PLANNING DIVISION STAFF REPORT

May 8, 2023

Project Address: 437-445 W Johnson Street, 430-440 W Dayton Street, and 215-221 N Bassett Street

Application Type: Zoning Map Amendment, Demolition Permit, Conditional Use, and Certified Survey Map Referral

Sheet Title
FIRST FLOOR PLAN

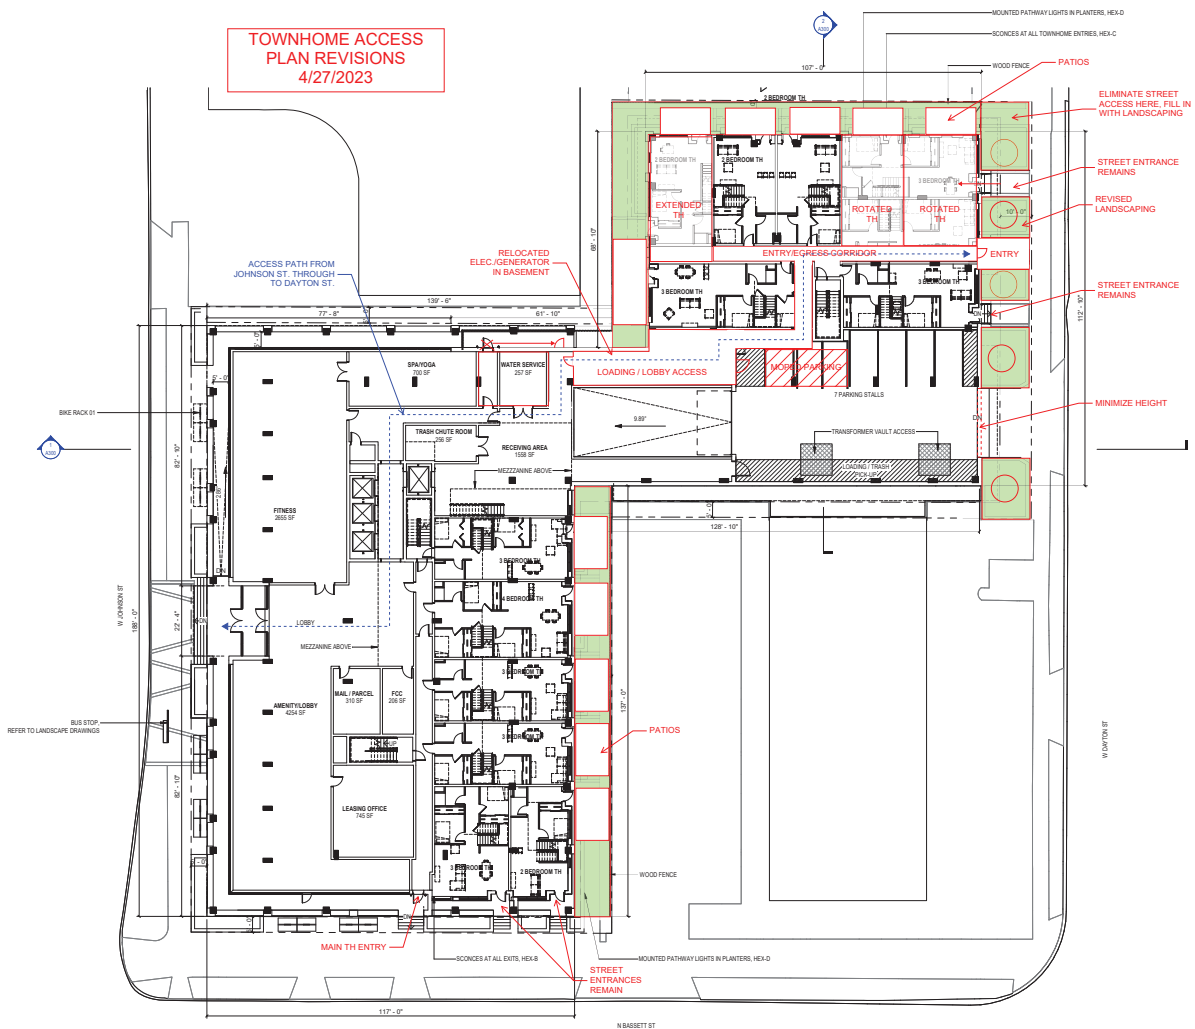
- a) The orientation ground level walk-up units shall be revised. Units shall have a primary entrance from an internal hallway within the building. Outdoor area shall be revised so these areas are either secondary or emergency entrances or reconfigured as private porches. Details on lighting and security shall be provided for approval of UDC and staff.

- The landscape concept sheet showing the green all the way around, how to get into those townhouses. What is the route from Johnson Street to get to that entry point? It's really pinched in there.

- Provide a common building entrance from Dayton Street.
- Lower the head height of the vehicle entry portal on the W Dayton Street elevation. The UDC noted that a detailed elevation or perspective of that façade that shows how the door is detailed, lit, framed would be helpful in determining that this condition is met.
- The lighting plans shall be revised to be consistent with City staff requirements for lighting, which can be reviewed and approved administratively.
